Cover Letter for re-use of Test Data

The initial application has been granted according to 47CFR Part 15C in October 20 of 2016, with the FCC ID: G95-UIW4010ECH

The new equipment to be Granted in this new application, according to **FCC ID: G95-UIW4010TCH**, only differs from the initial version (G95-UIW4010ECH) with the only 3 following points:

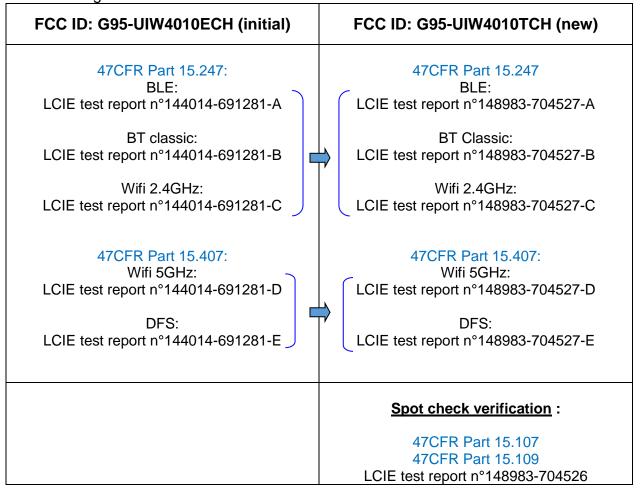
1. The ON/OFF switch has been moved from top PCB footprint to bottom PCB footprint

Please refer to the Internal Photos exhibits (page 5)
